# CITY OF ALBUQUERQUE

**Re: Applebee's Plat on 98<sup>th</sup> Street  
Conceptual Grading Plan  
Engineer's Stamp Date -no stamp- (K09D038)**

Based upon the information provided in your submittal received 1-14-15, the above referenced plan cannot be approved for Preliminary Plat action by the DRB until the following comments are addressed:

C1

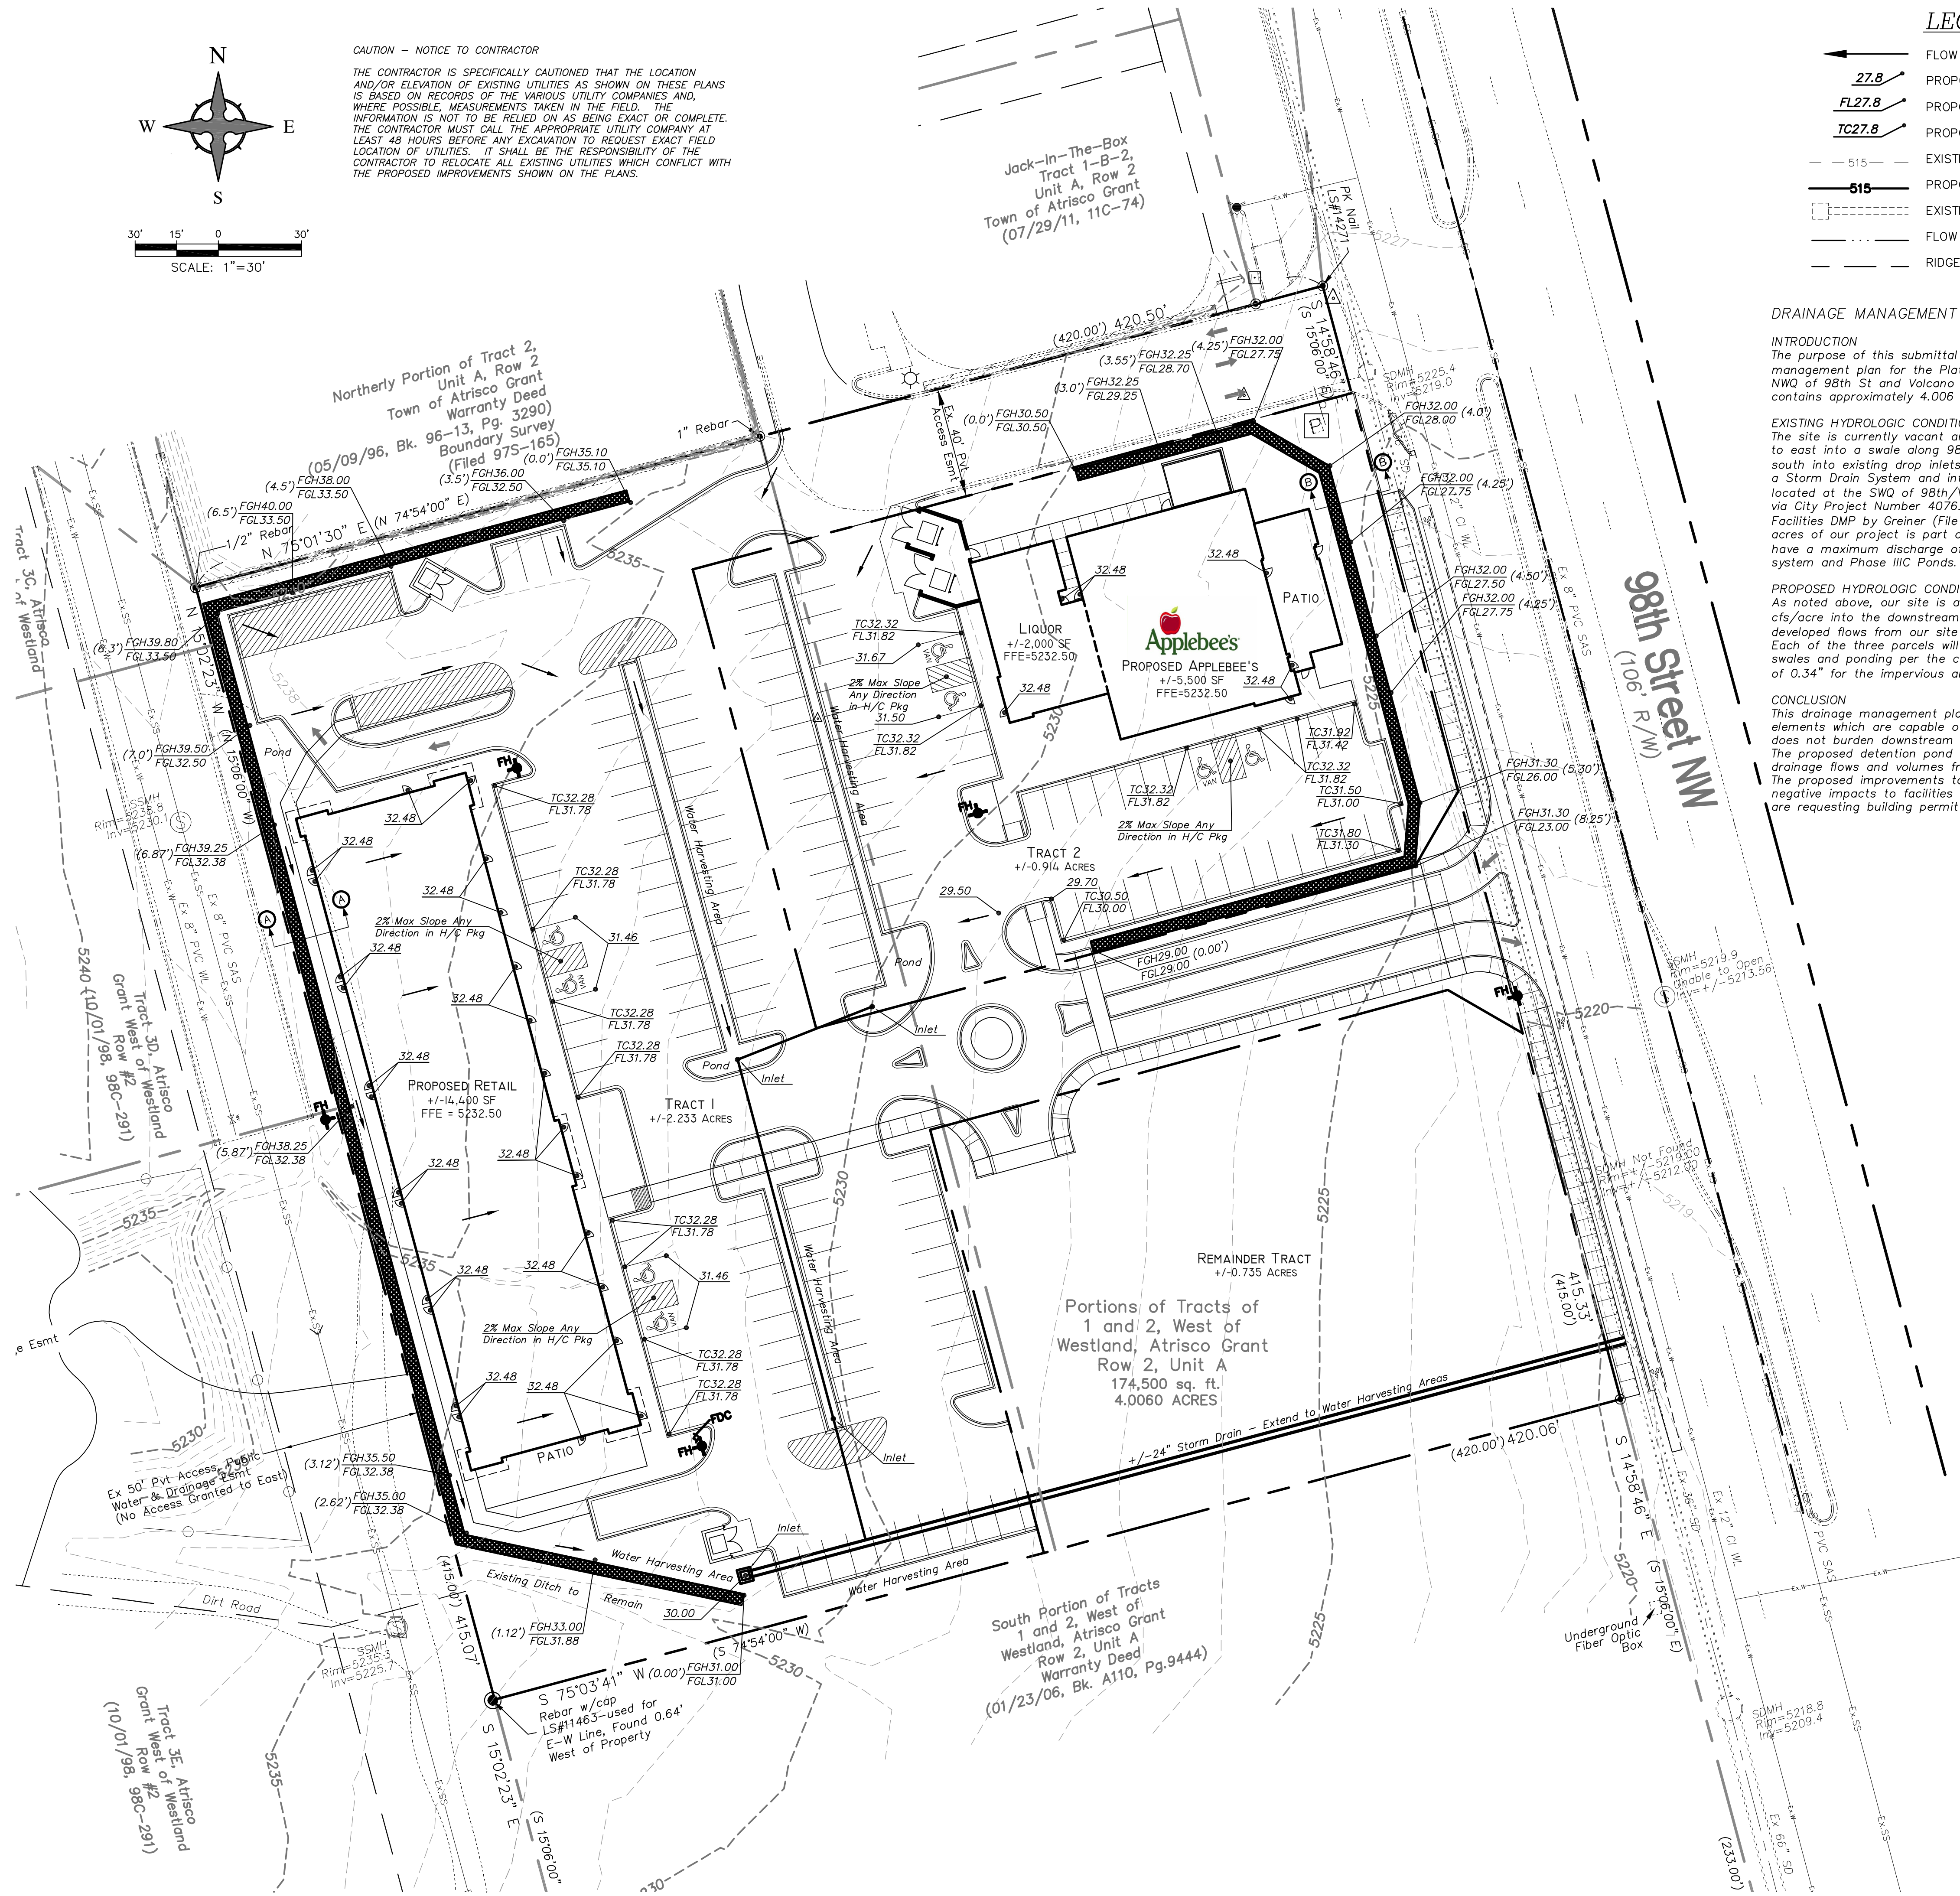
1. The plan submitted should be targeted towards addressing drainage infrastructure for the platting action. Showing the site is helpful for onsite drainage easements, however.

2. Show the contributing drainage basins to the storm drain. It appears the northern extent on 98<sup>th</sup> St. is the high point in the I40 off ramp.

3. The report to address the one-lane dry criteria.
4. Flows should be captured in the pipe in 98<sup>th</sup> st with little to no bypass south of Volcano Rd. It is acceptable to show a future inlet(s) south of this site as part of the report, depending on the one-lane dry criteria.

5. The report should be stamped and sealed.
6. This review does not include any of the onsite information shown on the plan as that will be addressed when a grading and drainage plan is submitted for Building Permit submittal.

7. This review is for the extents shown on the plan. If the land to the south is required to be incorporated into the platting action per the Subdivision Ordinance then the scope of the drainage report is to be increased to address the new platting boundaries.
